Technical Bulletin

Model
911 C2
Tiptronic

Subject: ATF Front Oil Cooler Line

Number
9205

Figure 1

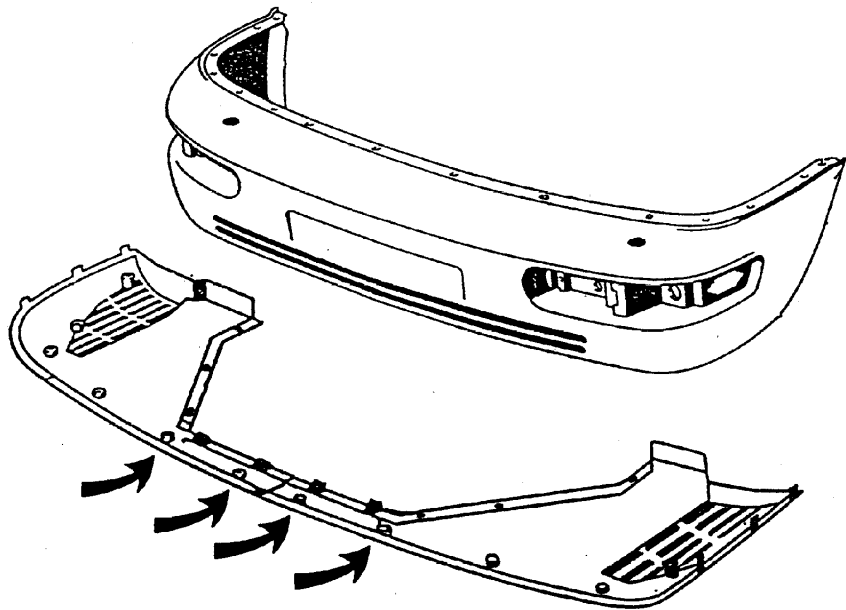
Concern: Correct installation of front lower panel mounting screws.

General Information: When installing the front lower panel on 911 C2 cars with Tiptronic transmission, the mounting screws (arrows, Figure 1) must be of the correct length. Failure to install the correct screws into the locations shown in Figure 1 can lead to damage of the transmission oil cooler line and Tiptronic transmission. After installing these four screws, mark the screw heads with a red paint dot.

Parts Information: Screw (Qty. 4) Part Number N 013 966 17
